National Infrastructure Planning Cleve Hill Solar Park CPRE Kent (Reference 2002146)

Written Representation: ECOLOGY AND BIODIVERSITY

Appendix 1. Natural dormouse nest found on Graveney Marshes 2019

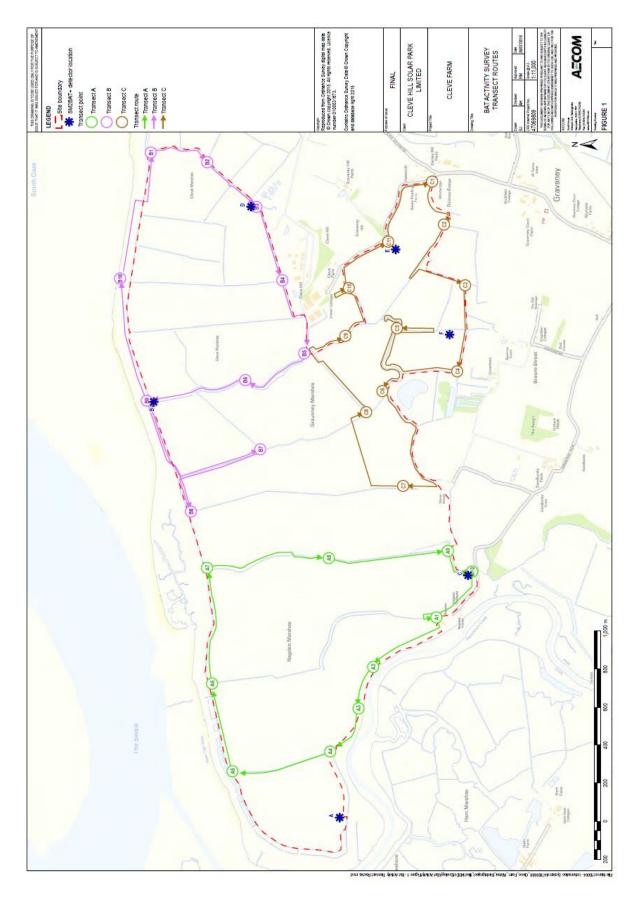
CHS failed to consider hazel dormice (*Muscardinus avellanarius*) in either the original Extended Phase 1 Habitat Survey or the Updated Extended Phase 1 Habitat Survey, yet there is clear evidence that hazel dormice are present on site, which would have been established had CHS considered dormice when carrying out their Phase 1 Habitat Surveys. (see Appendix 1: photograph of a dormouse nest present on the Local Wildlife Site (LWS) OS ref. TR026636). This nest has been recorded with PTES and NE and is now part of the National Dormouse scheme. It is likely dormice will have inhabited areas in and around the site, such as the ditch network and scrub.
